**ZONING BOARD OF APPEALS SPECIAL MEETING**  
**LOCATION: TOWNSHIP ANNEX, 7527 HIGHLAND ROAD, WHITE LAKE, MICHIGAN 48383**  
**THURSDAY, MAY 25, 2023 – 5:00 PM**

**TO:** Zoning Board of Appeals  
**FROM:** Justin Quagliata, Staff Planner  
**DATE:** May 25, 2023

**Site Plan**  
 Owner: Michael & Julie Beals  
 (810) 936-3065  
 8468 Cascade St Commerce Township  
 PN: 12-36-453-022  
 Engineer: Eric S. Heethuis, P.E., P.S.  
 14305 Wright Dr Linden, MI 48451  
 (517) 202-4806  
 5/01/2023

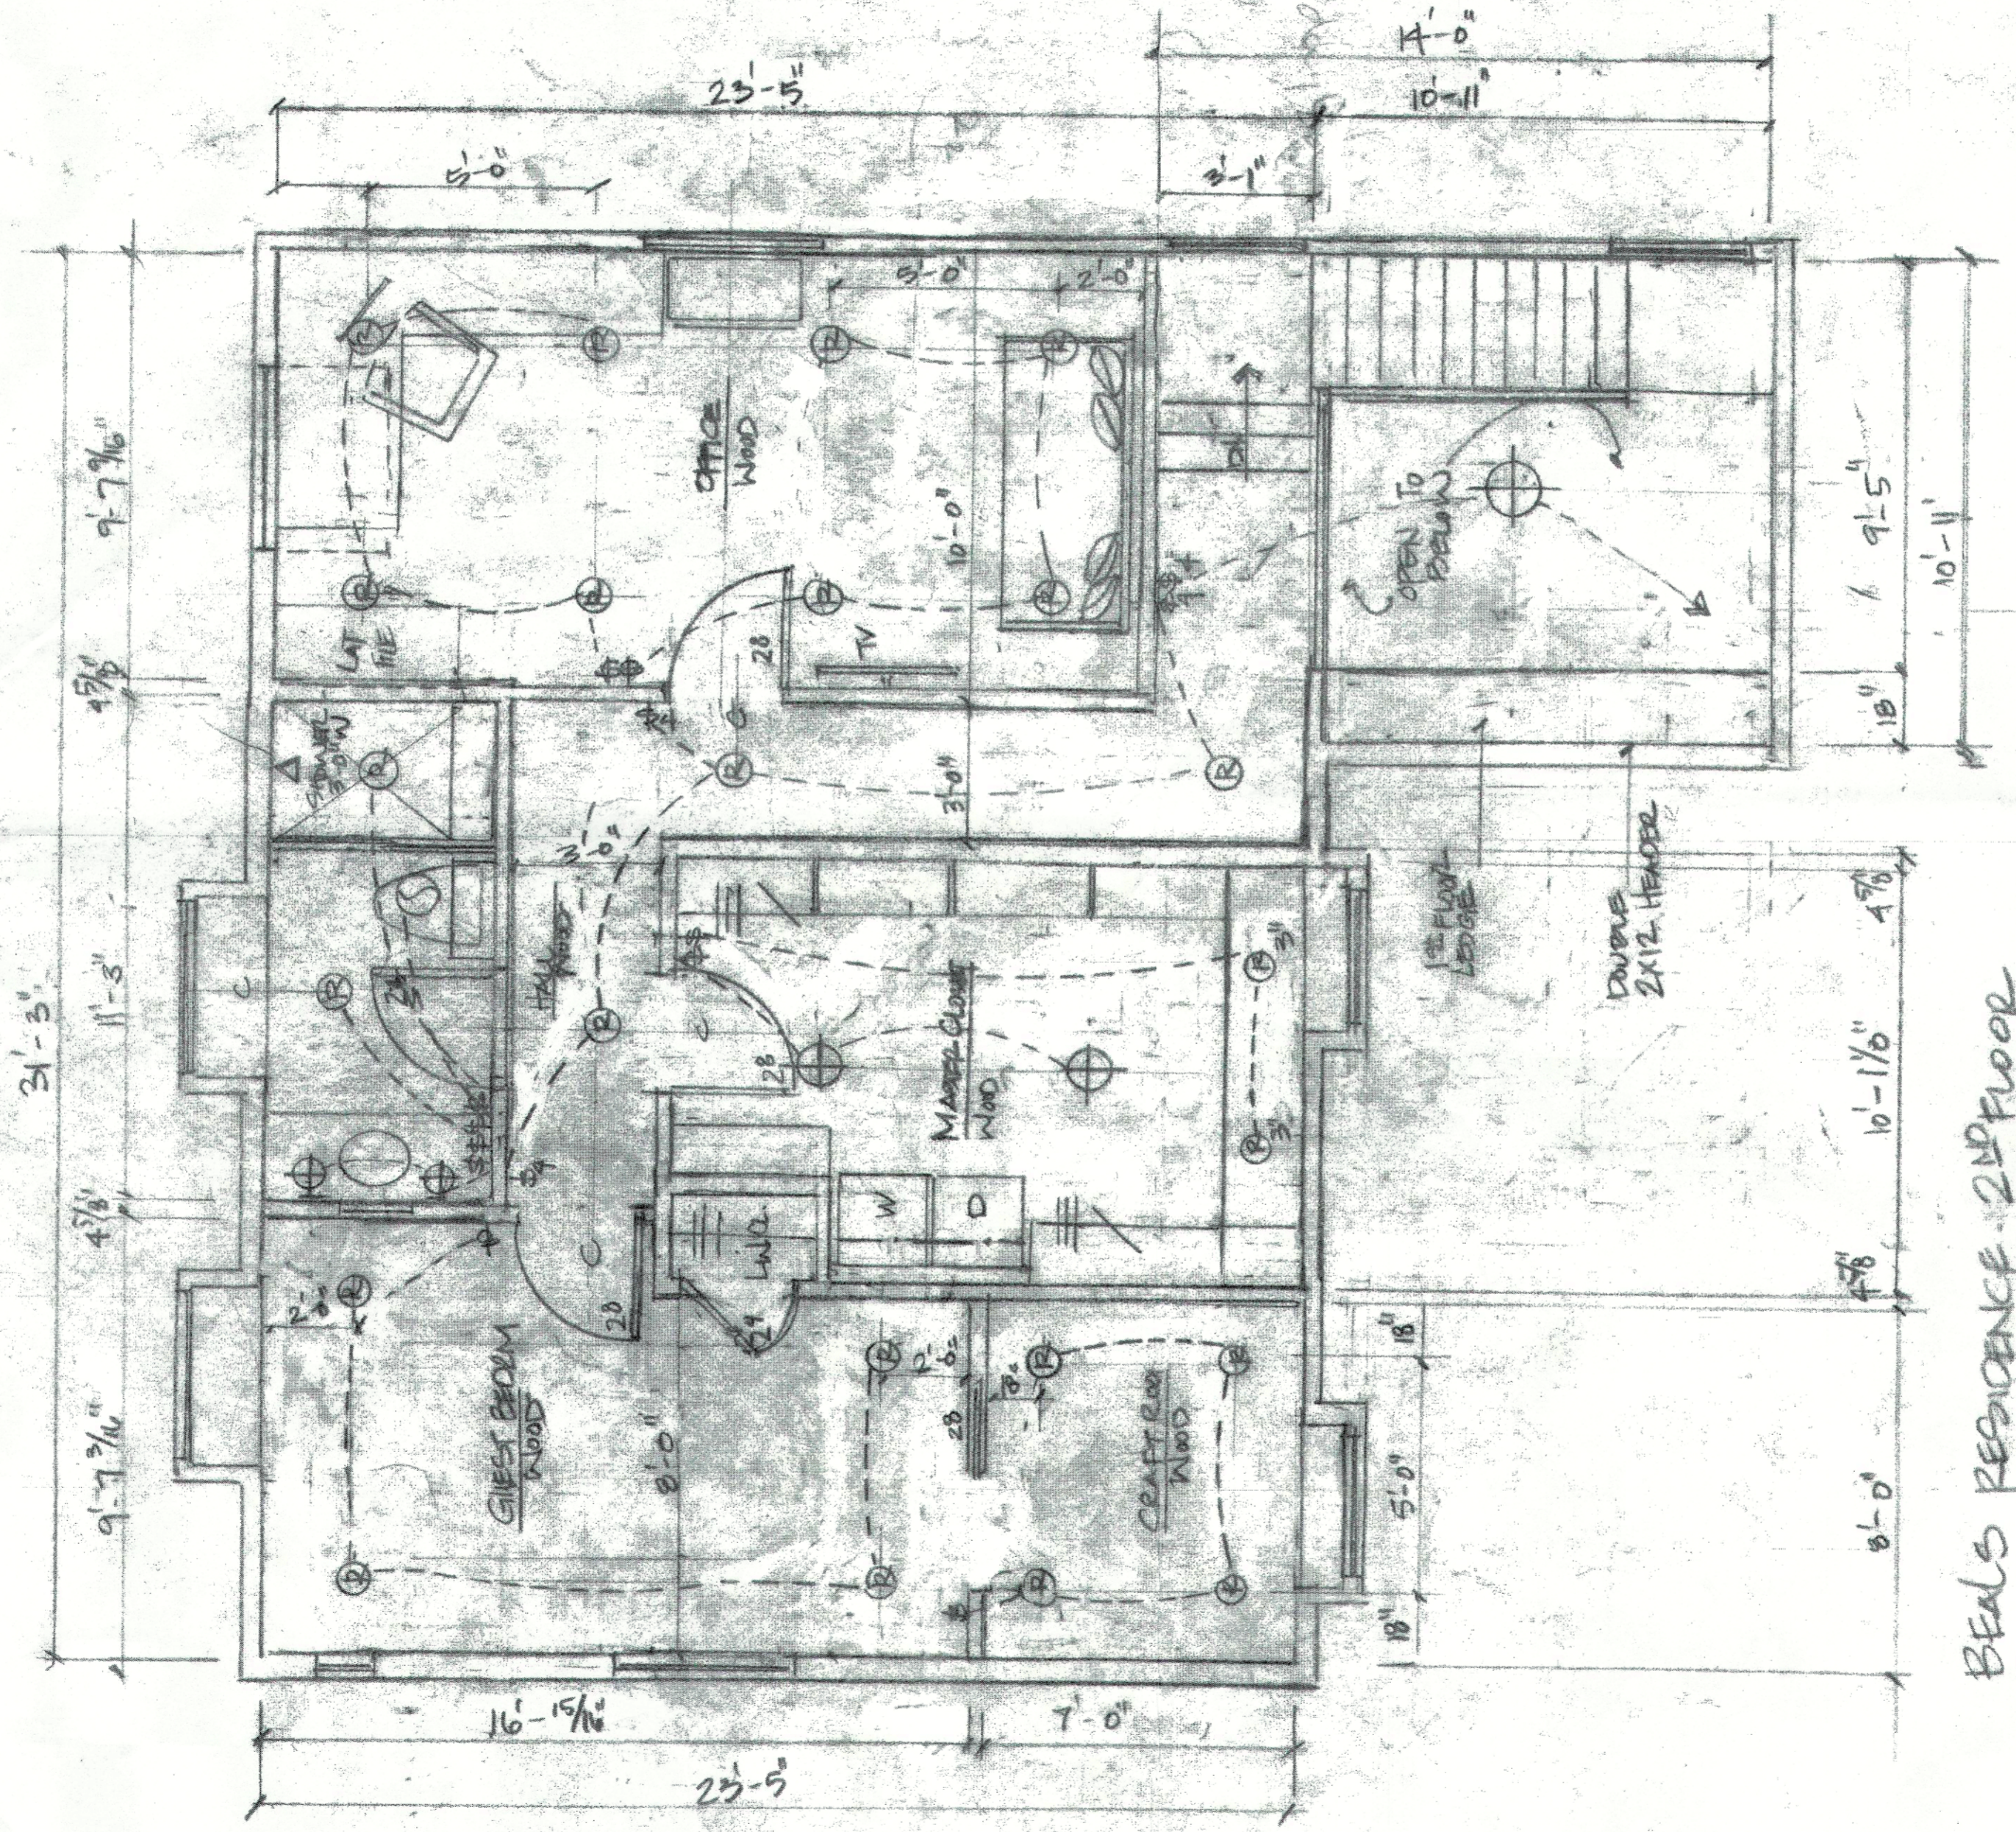
Currently the existing house is nonconforming; the building is located 8.68 feet from the west side property line. A minimum 10-foot side yard setback is required in the R1-D zoning district. According to the submitted site plan, the addition on the front of the house is approximately 601 square feet in size and the addition on the rear of the house is 180 square feet in size. As proposed, the addition on the front of the house would connect to the existing detached garage. Based on the submitted site plan, the garage is nonconforming with a 25.73-foot setback from the front property line (a minimum 30-foot front yard setback is required in the R1-D zoning district) and a 4.55-foot setback from the west side lot line. If the garage becomes part of the principal building (by attachment to the house or locating within 10 feet of the house), it would be subject to the 10-foot side yard setback requirement in the R1-D zoning district. Section 7.27.vii of the Zoning Ordinance prohibits the Zoning Board of Appeals (ZBA) from granting a variance to permit a setback of less than five feet from a side lot line for safety reasons. If the ZBA approves the request, approval would have to be conditioned on the Applicant being required to reconstruct the west wall/roof overhang of the garage to be five feet from the side lot line. Additionally, the proposed lot coverage is 22% (2,867 square feet), which is 2% (256 square feet) beyond the allowable limit (2,611 square feet).

The ZBA should note the submitted architectural plans are inconsistent with the site plan, and while some architectural plan sheets indicate a scale, the plans are not drawn to scale. Based on the house plans, the footprint of the building is larger than indicated on the site plan. According to the site plan, the house at its closest point would be located 5.68 feet from the west side lot line; the architectural plans appear to show the proposed addition on the front of the house approximately one foot from the west side lot line (not including the roof overhang).

- An as-built survey shall be required to verify the approved setbacks and lot coverage.
- The west side wall of the garage shall be removed and reconstructed to establish a five-foot side yard setback, which shall be measured from the roof overhang of the garage.

- In no event shall the projection of any roof overhang be closer than five feet to the west side lot line.
- A revised building permit application shall be submitted and the building permit fee shall be based on a value of improvement of \$130,548.60.

- The architectural plans shall be revised to be consistent with the site plan prepared by the surveyor.
- The notes on the architectural plans regarding not scaling the drawings shall be removed. The architectural plans shall be drawn to scale to the satisfaction of the Building Official.

SCALE:	1" = 20'
SHEET NO.:	L1.01
DATE:	KE 2022.226

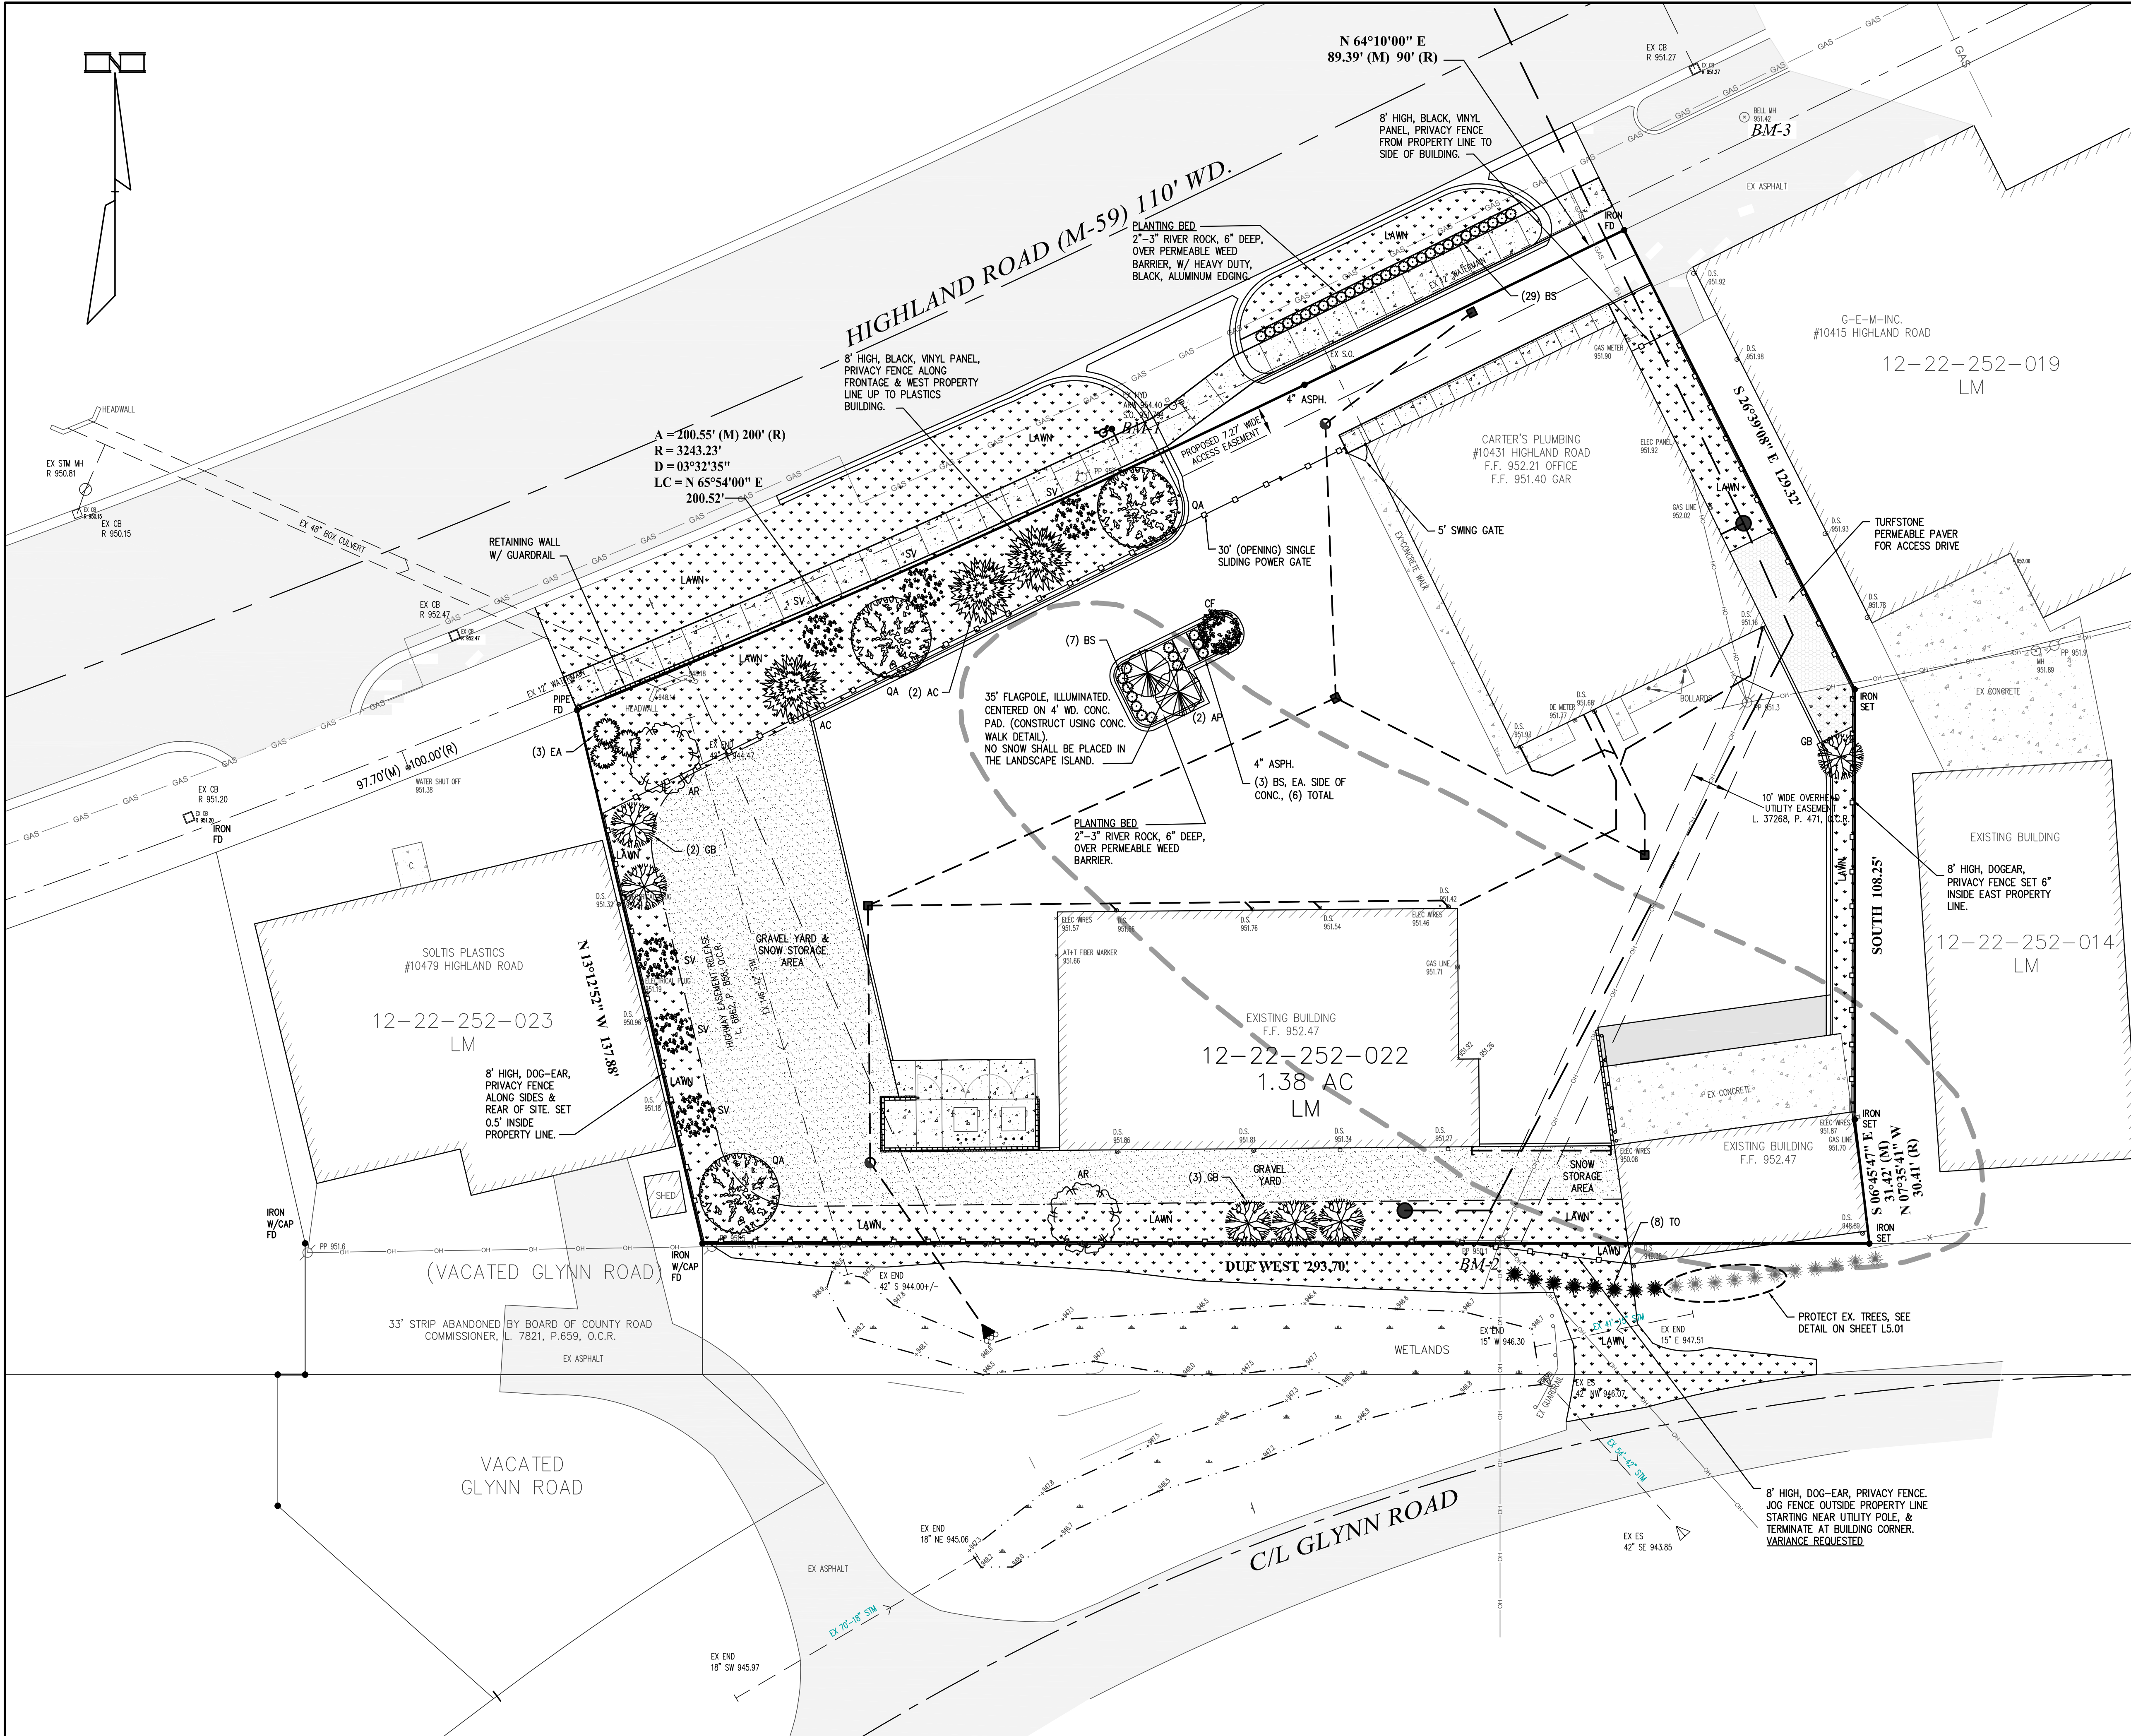
- A variance shall be requested from the Zoning Board of Appeals as the required parking lot landscaping is not proposed to be installed. Revise the parking lot landscaping note on Sheet L1.01 to reference the required variance. **(Comment rescinded. The Applicant incorrectly utilized the commercial/office use schedule for parking lot landscaping. The industrial use schedule applies to this site. Therefore, sufficient parking lot landscaping is proposed).**

- All required landscape areas in excess of 200 square feet shall be irrigated to assist in maintaining a healthy condition for all plantings and lawn areas. An irrigation plan shall be provided. The irrigation notes on Sheet L1.01 shall be relocated to the irrigation plan. **(Comments addressed. An irrigation plan has been added to the revised plan set, and notes have been relocated accordingly).**

- Remove note 2.3 under required screening on Sheet L1.01. **(Comment outstanding. As previously stated, this is not a required variance).**
- Lawn in the Highland Road front yard shall be sod and lawn elsewhere shall be hydroseed or sod. **(Comment addressed. A note has been added to the landscape specifications on Sheet L5.01).**

- The Landscape Schedule on Sheet C5.01 identifies a certain number of White Flowering Dogwoods with inconsistent symbols for those plantings depicted on Sheet L1.01. Revise accordingly. **(Comment addressed. The planting call-outs have been corrected on the landscape plan).**
